Summit County Planning Commission (SCPC)

Thursday, February 22, 2024 - 3:00 p.m.

Meeting Agenda

Planning Commission
Preliminary Plan
Kingdom Preserve
Springfield Township

KINGDOM PRESERVE
SPRINGFIELD TOWNSHIP
SUMMIT COUNTY, OHIO

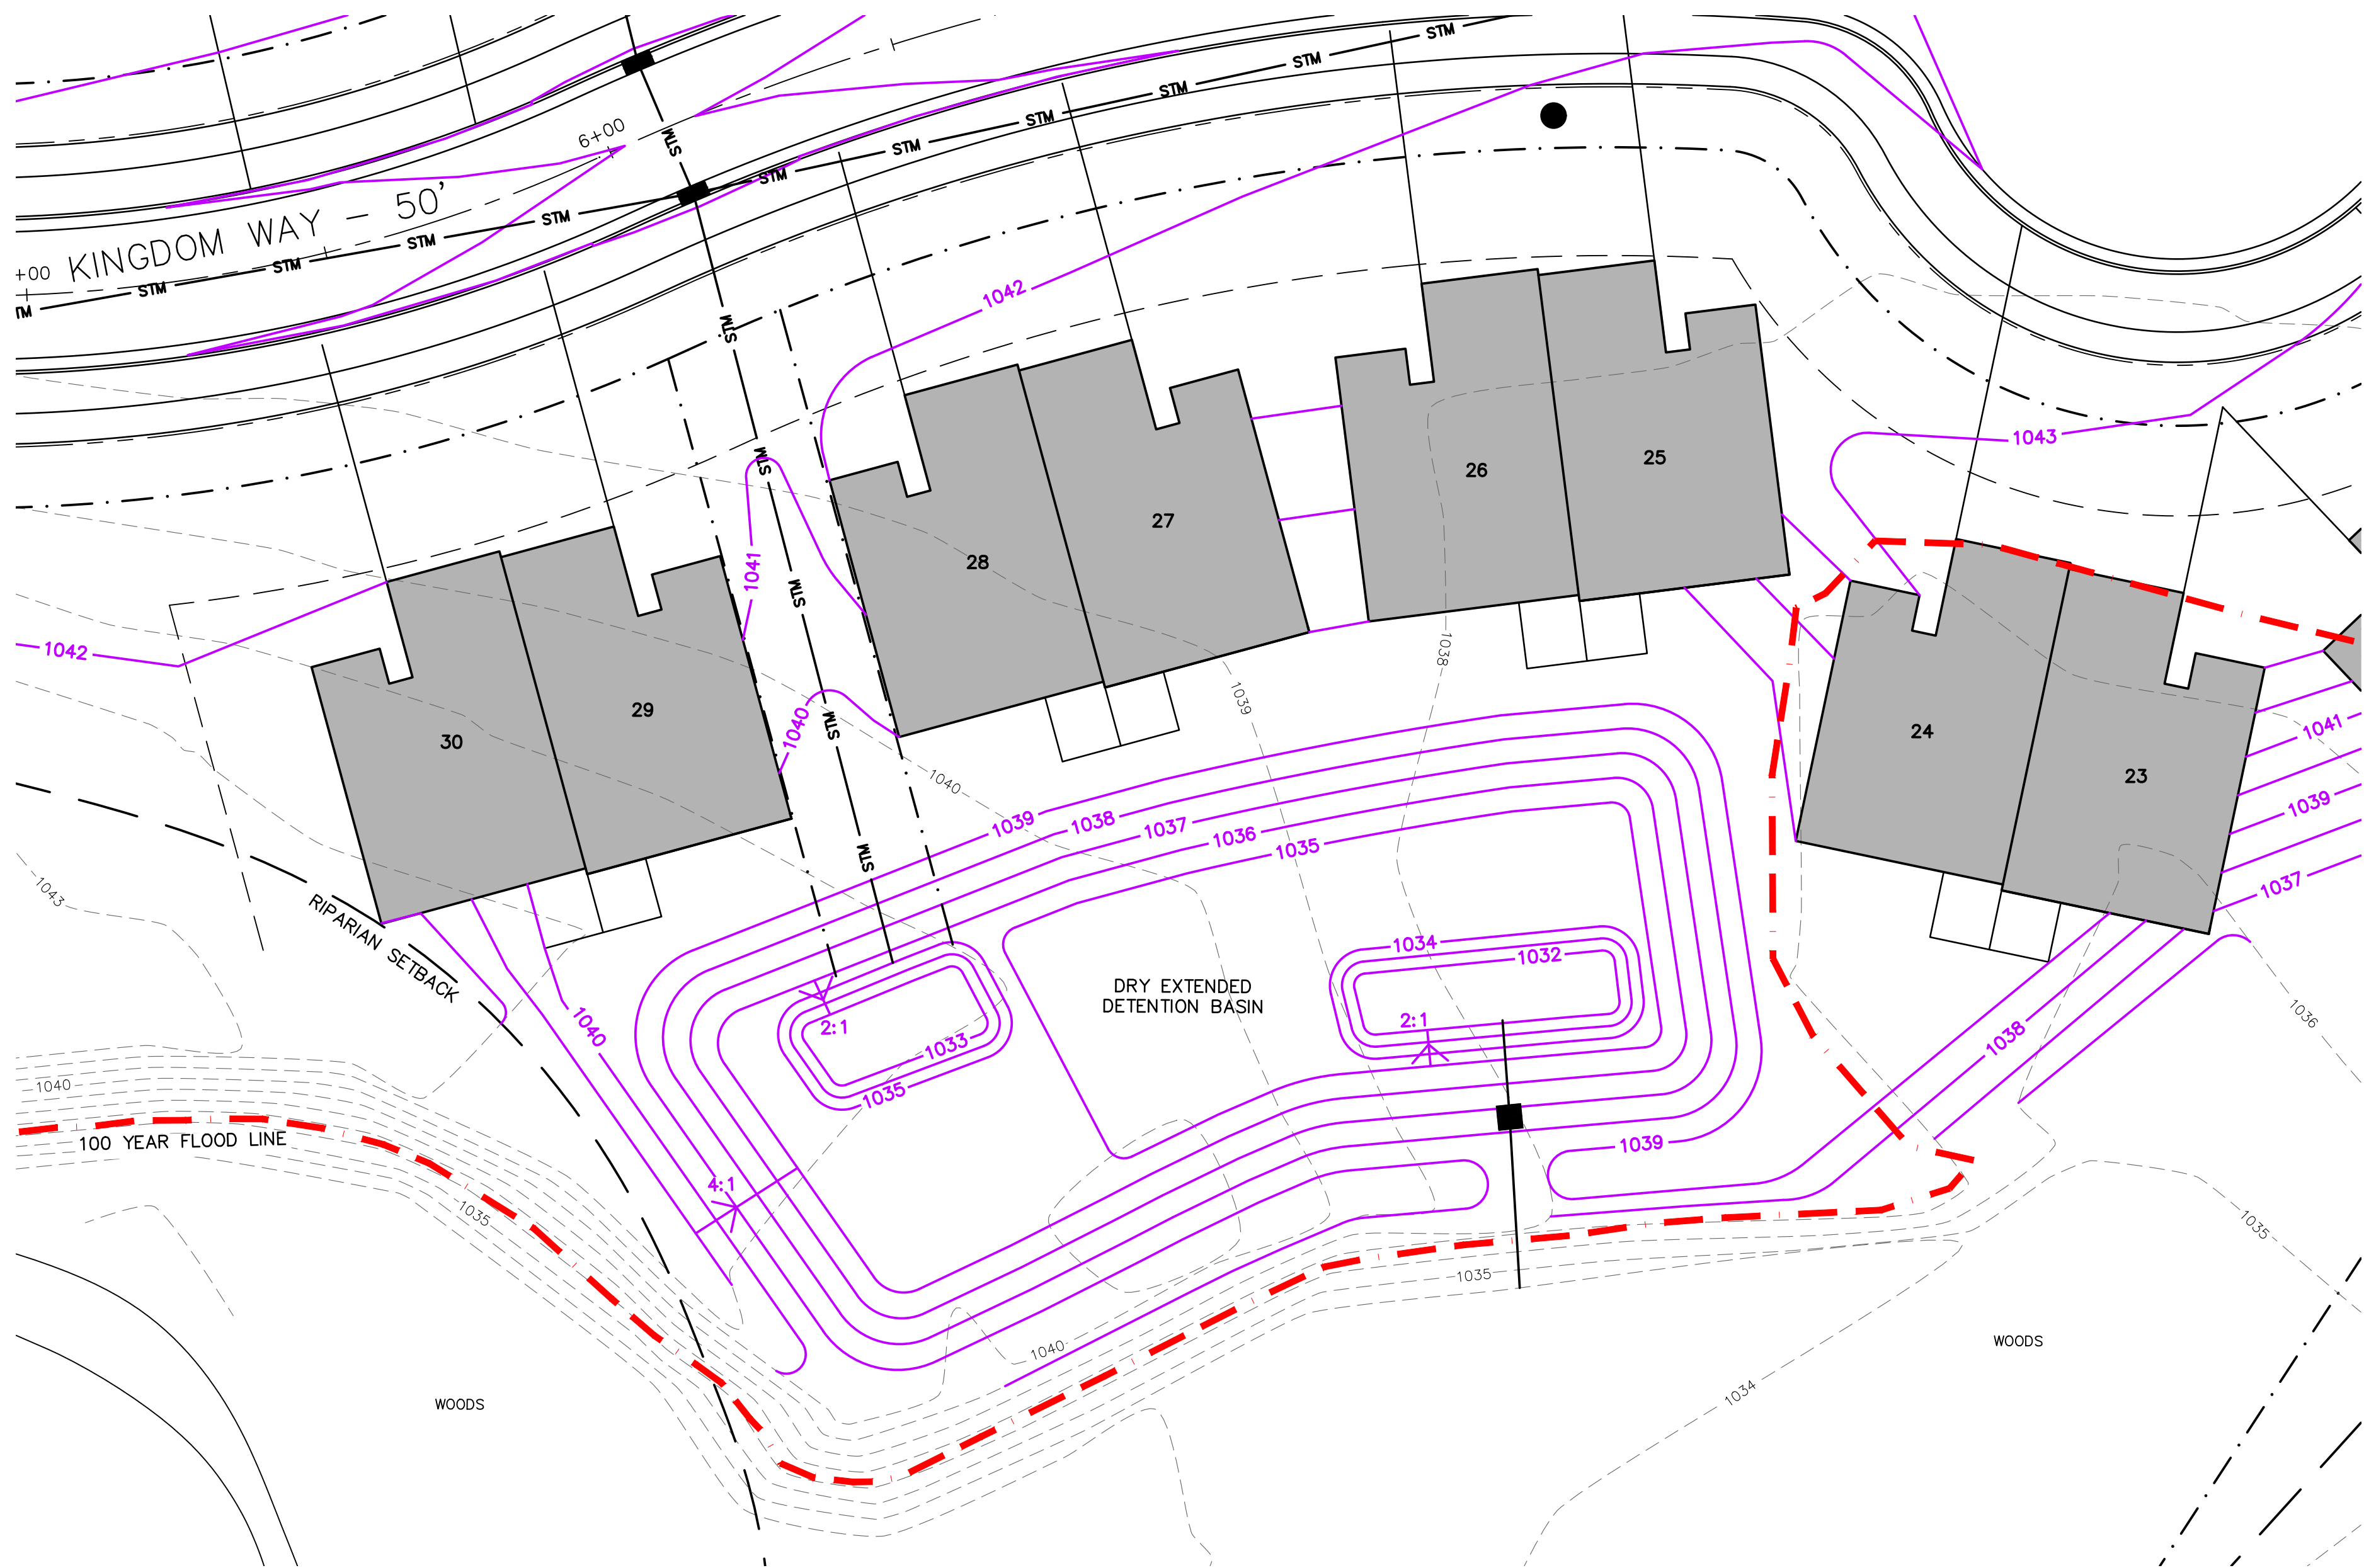
SCE: Andy Dunchuck, 12/18/2023: *Our office has reviewed the above referenced and attached Preliminary Plan and has the following comments. If you have any questions regarding this matter, please contact our office.*

1. *All Stormwater Management for the site must follow the SCE Stormwater Drainage Manual, Current Edition (Revised 1/1/20). All SWM Facilities must be located outside of the Wetland and Riparian Setbacks and the 100-Year Flood Plain. In addition, the outlet pipe for the proposed SWM Basin must have an adequate outlet.*

4. *The Intersection Sight Distance for proposed access onto Killian Road must be verified for a Design Speed equal to 45-mph.*
5. *A Traffic Impact Questionnaire for the project must be completed to determine if additional Studies are warranted.*

6. *Since the proposed road will be servicing 36 Units, the road is classified as a Residential Medium Traffic Road which requires a minimum 26' Wide Pavement (Curb and Gutter) or 24' (Open Ditch). In addition, the plan indicates a 50' Access and Utility Easement in lieu of R/W. Is this being proposed as a Private Subdivision?*

11. *Provide a Wetland Delineation for the Project.*
12. *Part of Unit 22 and all of Units 23 and 24 are located within the 100-Year Flood Plain.*

-
13. *The Proposed Utilities must be located outside of the pavement.*
 14. *A Road Opening Permit will be required for the proposed work within the R/W of Killian Road*

1. *It does not appear that our Riparian setback standards have been taken into account. All of our setback standards have greater adjustments than Summit County's as of July 2023. I have attached the entire Riparian Setback Standards document. I have also attached parts of this document where I have highlighted sections that show greater adjustments that would apply. From what I can tell, it looks like condo 21, 22, 23, 24, 29, 30, 35, 36 may all be affected.*
2. *As for rear setbacks, condo 1, 18, 19, 20, 33, 35 may not be set back at least 40'.*
3. *Is there 10' between all condos at their closest points?*
4. *Does the common drive allow a 10' easement next to it? What is the width of it and there is no turn-around.*
5. *Is the distance between the rear of condo 34 to the front of condo 35 at least 60' and condo 25 to 24?*
6. *Is this a private road or a public road?*

Recommendation: It is Staff's recommendation that the SCPC **Table** this Preliminary Plan so the applicant can address Township and SCE concerns and to submit applications for any variances required.

Planning Commission
Riparian Variance
4501 Kings Ridge Dr.
Richfield Township

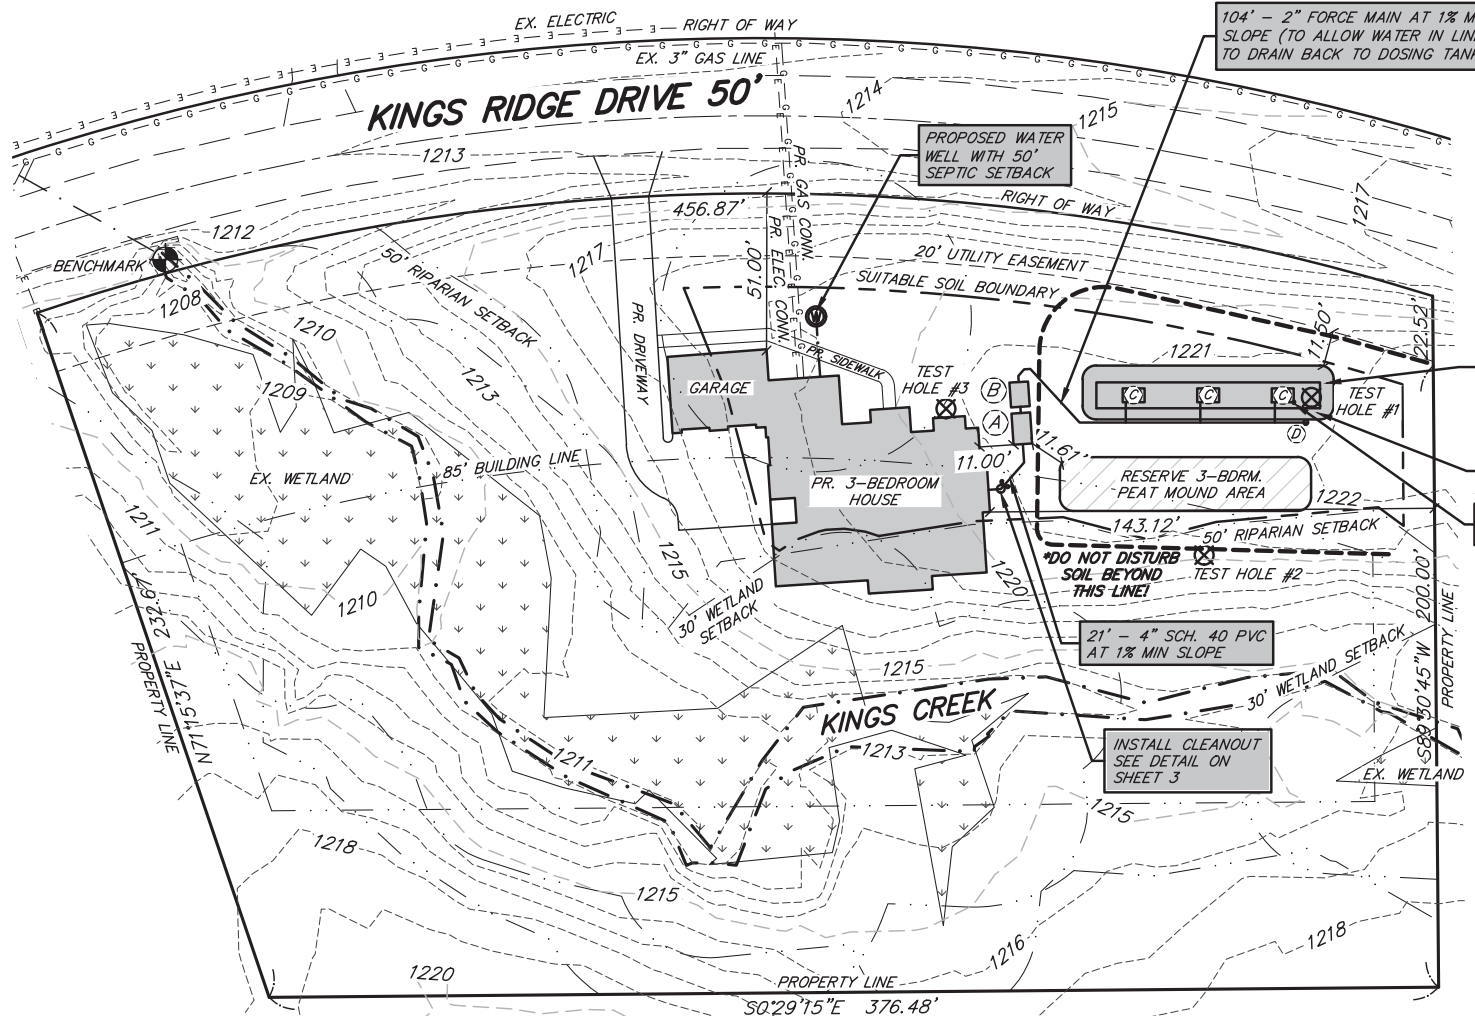
- *Should a variance be granted, I would like to bring the following to the attention of SCPC members: The predominant soil type within the proposed work location is WaB (Wadsworth silt loam). WaB has a seasonally high-water table, which is a major limitation for use. Erosion is a hazard if the surface is disturbed. Heavy use when wet will cause soil compaction and reduce growth. A thick plant cover will help control erosion. As a result, proper erosion and sediment controls need to be incorporated into the design of the site to ensure that the riparian setback is protected.*

- *In section 937.06(b)(1) it states “erosion control may be allowed if such practices are within permitted uses by the local, state, and federal government regulations and are ecologically compatible and emphasize the use of natural materials and native plant species where practical and available. erosion control practices shall only be undertaken upon approval of a Stormwater Pollution Prevention Plan (SWPPP or SW3P) by the Summit SWCD.” Since the use of such practices within the setback is practically assured, A SWPPP will need to be submitted to Summit SWCD for review prior to commencement of any construction activities.*

- *The latest proposal for this project has seen the riparian/wetland setback impacts reduced from 0.23 ac to 0.051 ac. This decrease has been achieved by a proposed front yard setback variance from the township as well as a modification to the overall design.*

**Environmental Health Division****scph.org****Sewage Treatment System (STS) Design Plan and Field Verification Checklist:****Property Address:** 4501 Kings Ridge Dr **Parcel #:** 48-02421

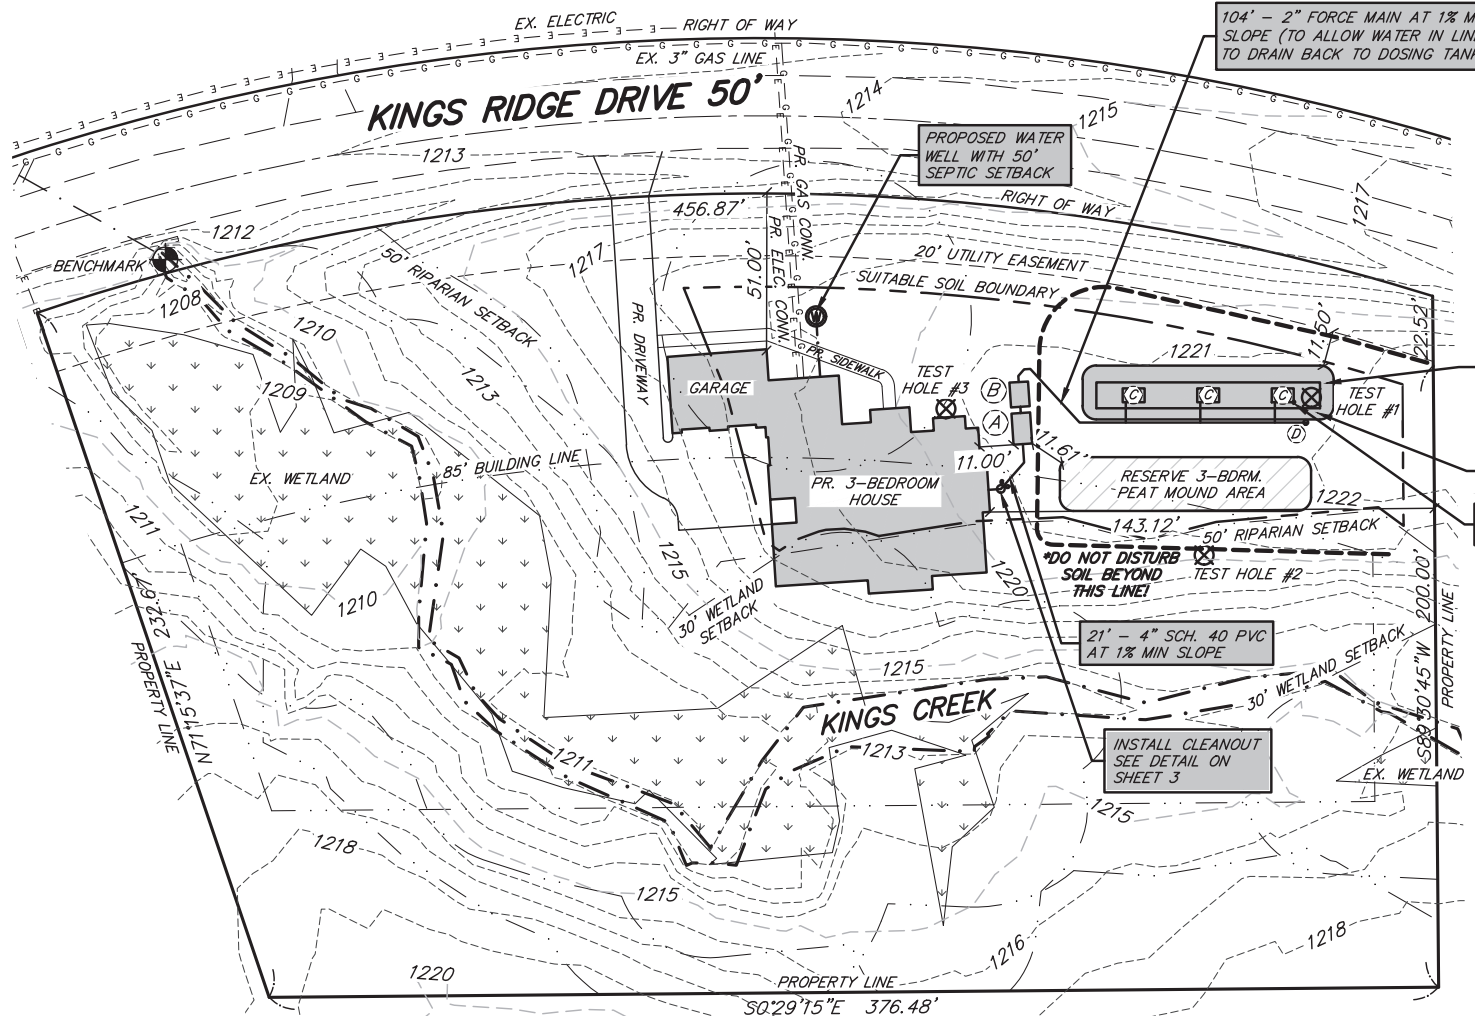
-Peat mounds must be marked out on site prior to approval of design plan

Cannot approve septic design plan until an approvable topographic site improvement plan is received
